URBAN DESIGN COMMITTEE STAFF REPORT

APPLICATION NUMBER	Urban Design Record #24093
APPLICATION TYPE	Advisory Review and Final Action
ADDRESS/LOCATION	S 21 st and O St
HEARING DATE	July 9, 2024
ADDITIONAL MEETINGS	-
APPLICANT	Karen Kunc, karen@constellation-studios.net
STAFF CONTACT	Arvind Gopalakrishnan, 402-441-6361, agopalakrishnan@lincoln.ne.gov

CONSTELLATION STUDIOS ADDITION

6 NORTH ELEVATION
1/8" = 1'-0"

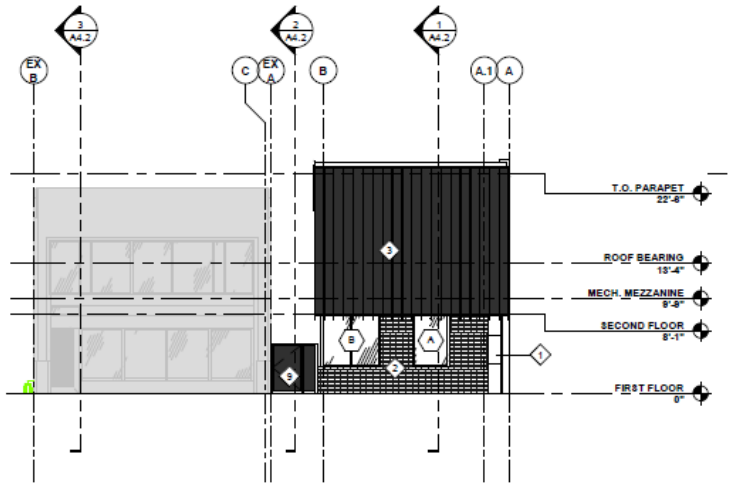
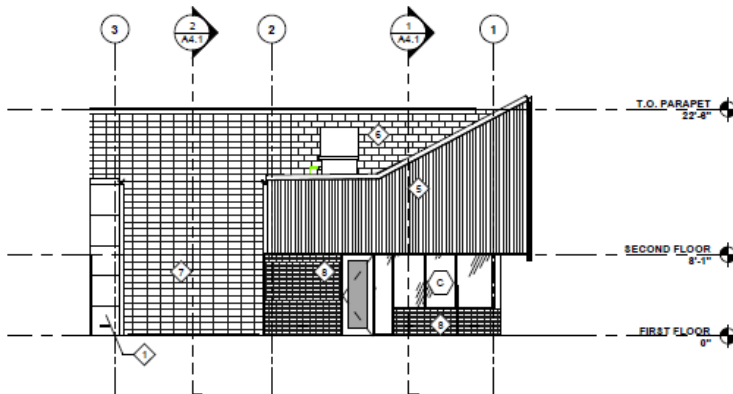
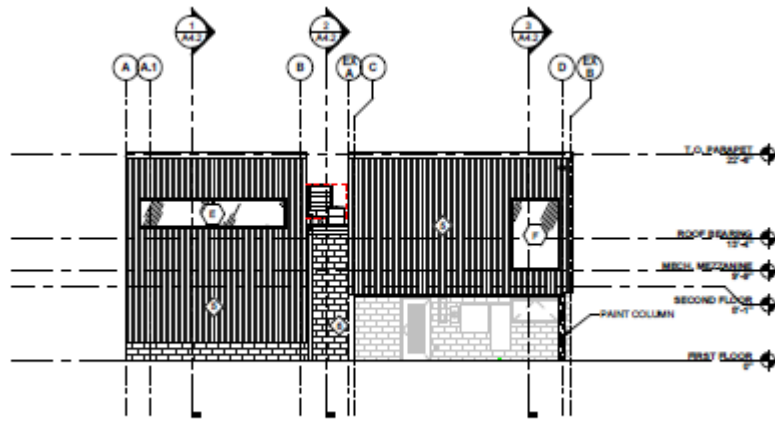
Mechanical equipment on rooftops shall be architecturally screened with materials compatible with the main walls of the building so they are not visible from adjacent streets. – **Compliant**

The mechanical equipment on the roof of the new building will be screened by the existing building, and hence, won't be directly visible from the street.

1 ARCHITECTURAL SITE PLAN
 1/8" = 1'-0"

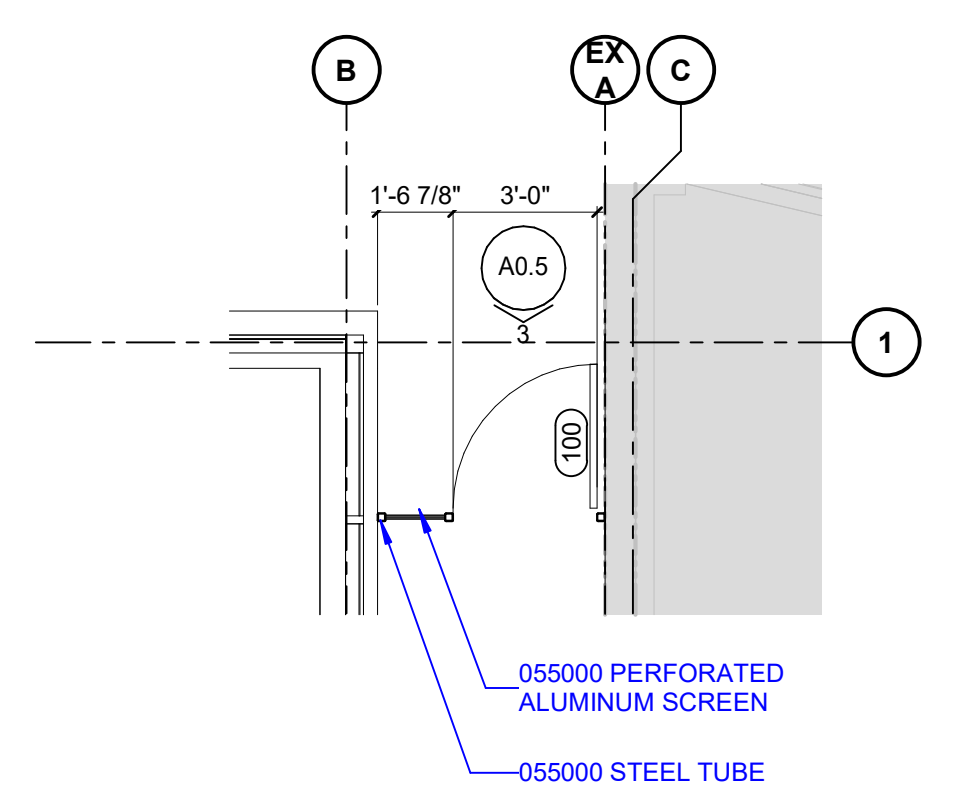
In recent meetings with the design group and City staff, it was determined that bollards along the sidewalk are not an optimal solution to prevent cars turning onto 21st St from encroaching onto the sidewalk. Given the location within the BID, the Downtown Landscape Association (DLA) could help with the installation of a planter as an alternative solution. The planter would serve the same functional purpose while enhancing the aesthetic appeal of the area.

It is crucial to note that the sidewalk must maintain at least 5 feet of uninterrupted space to comply with ADA regulations for accessibility and pedestrian crossing purposes.
